Our Ref: PC55 – 21/489
Enquiries to: Joao Paulo Silva

Acknowledgement of Plan Change Request – Private Plan Change 55: Development Concept Plan for Waitoa Dairy Manufacturing Facility - Request for Further Information (Clause 23, RMA Schedule 1).

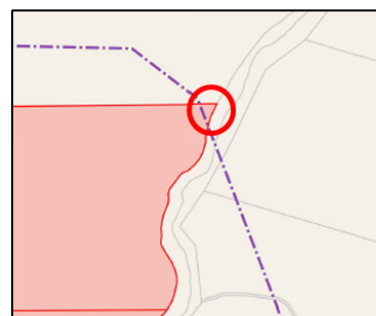
MPDC will also include the location of the NECB on the electronic version of the District Plan, using a shapefile that you need to provide to us. We attach a print-out (Attachment 3) of the shapefile that you provided with your plan change request. You will note that there is a discrepancy in the northern corner of the site (see snip below) where the NECB needs to be relocated to align with the property boundary as shown on the drawing attached to the Marshall Day Report (Appendix A to your plan change request).

Please provide an amended shapefile adjusted to correctly reflect the location of the NECB.
